REFERENCE:	TSB: 08-183-23 GROUP 08 - Electrical	Date:	July 26, 2023	REVISION:	
VEHICLES AFFECTED:	2020 (DJ) RAM 2500 Pickup 2020 (D2) RAM 3500 Pickup 2020 (DD) RAM 3500 Cab Chassis 2020 (DF) RAM 3500 <10K Cab Chassis 2020 (DP) RAM 4500/5500 Cab Chassis 2020 (DT) RAM 1500 Pickup NOTE: This bulletin applies to vehicles equipped with a Uconnect 12.0 With Navigation radio (Sales Codes UAX or UCX).			MARKET APPLICABILITY:	
				<input checked="" type="checkbox"/> NA	<input type="checkbox"/> IAP
				<input type="checkbox"/> EE	<input type="checkbox"/> MEA
				<input type="checkbox"/> SA	<input type="checkbox"/> CH
CUSTOMER SYMPTOM:	Customers may experience one or more of the following: <ul style="list-style-type: none"> • Mobile Wi-Fi inoperative upon start up. • Hotspot gives "No Internet" connection message on phone when trying to connect to a device. 				
CAUSE:	Radio software

REPAIR SUMMARY:

Fig. 3
Update In Progress Screen

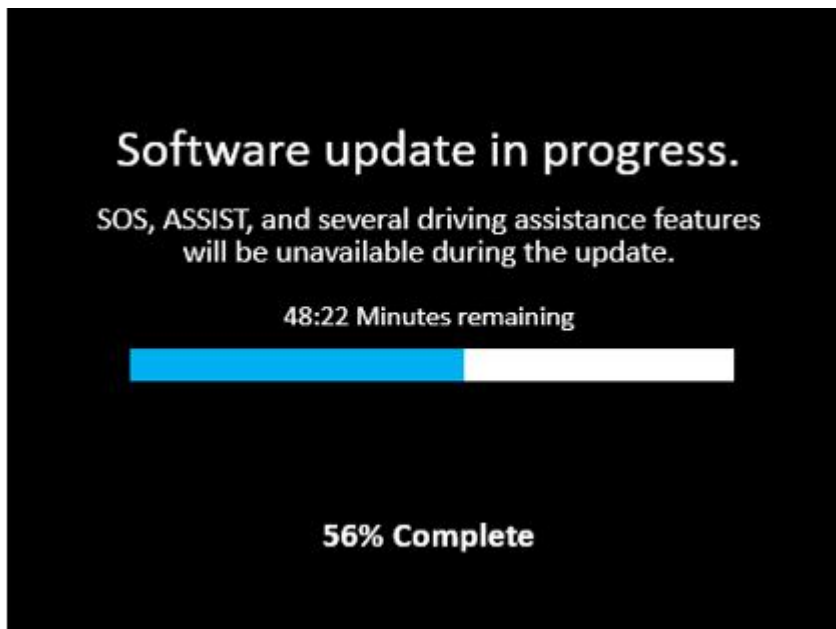
- Whether the customer selects "Update Now" or "Schedule Update" (Fig. 1) and sets a time, they can shut off the vehicle and leave. The update will be completed automatically (Fig. 3) .
